## ***Interactive comment on “Sensitivity and identifiability of rheological parameters in debris flow modeling” by Gerardo Zegers et al.***

Received and published: 18 April 2020

**Fig. 1.** Effect of the sample size  $N_k$  on the cumulative distribution function (CDF) of DELSA indices for parameters  $\beta_1$  (top) , and  $Cv_{\text{max}}$  (bottom) at the Acerillas creek.

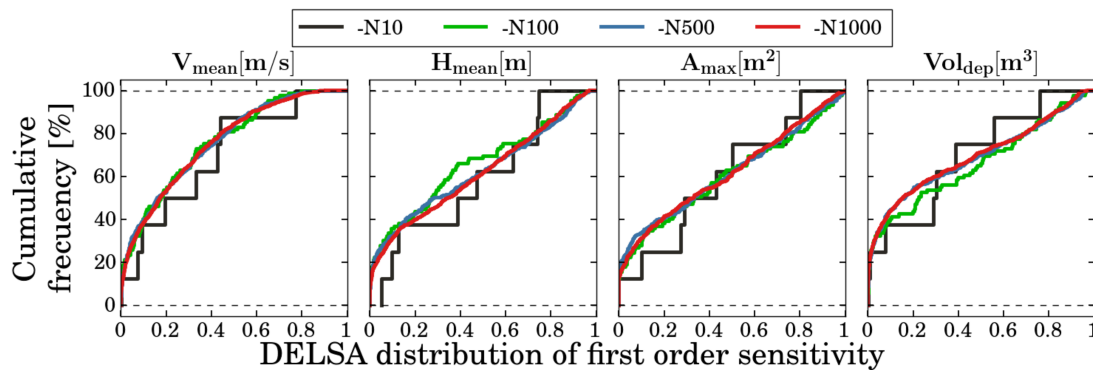
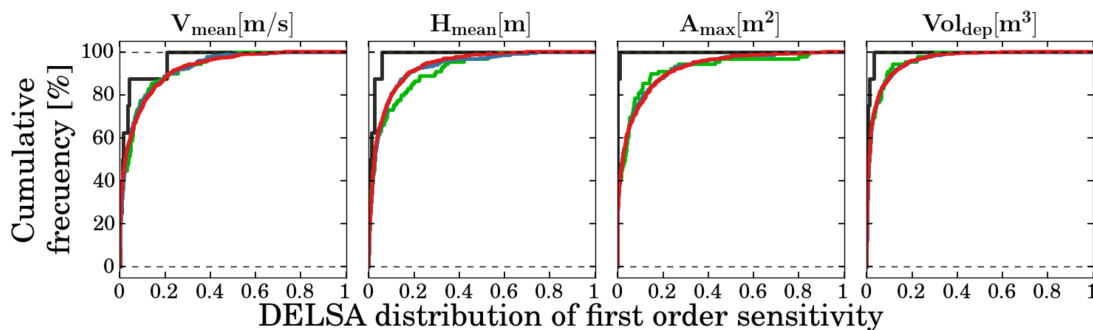
effects on key simulated variables. Further, Chow et al. (2018) analyzed changes in  $C_v$  ignoring the effect of the total sediment volume, whereas we examine the effects of total volume and sediment concentration separately, obtaining that the total sediment volume is more important than the maximum sediment concentration. Finally, Chow et al. (2018) used fixed sets of parameters related to viscosity and shear stress, reporting thus an aggregate effect of a bigger variation of these parameters. In this study, we analyze parameter importance through local sensitivities across the entire parameter space, recognizing that the relative importance of parameters can change depending on the sub-region examined. This effect is shown in Fig. 1 through the cumulative frequency distribution of DELSA indices for  $C_{vmax}$  on the mean Velocity. For 60

**Fig. 2.** (a) Location of the two case study creeks and reference models results. The maximum observed flood areas and modeled flow depth (reference models) are shown for (b) Acerillas creek, and (c) La Mesilla

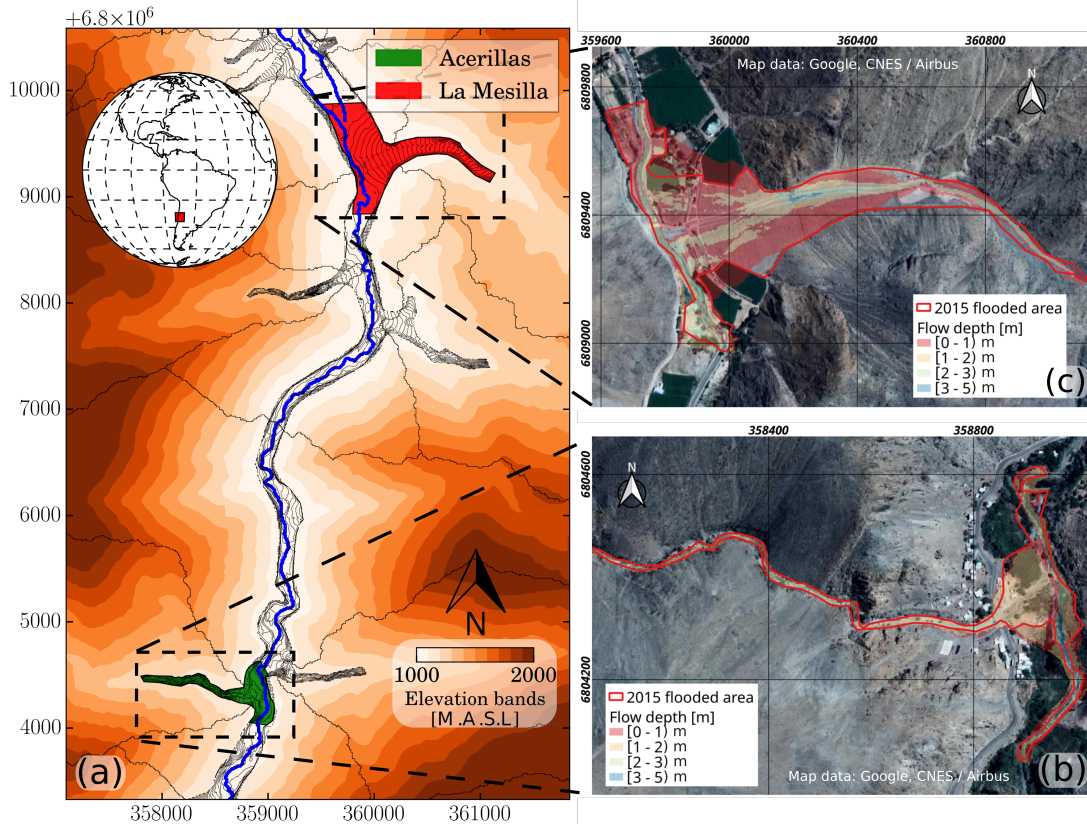
Fig. 1: Nice figure, but two remarks: (i) The lines in the overview pane leading to the detailed map of La Mesilla should pass behind the legend, and not in front of it. Further, it would look better if the lower line for La Mesilla would start at the southern end of the deposit. (ii) The threshold values in the legends are ambiguous: >0-1 m; >1-2 m etc. would be correct.

We thank the reviewer's suggestions. The new Figure will look like:
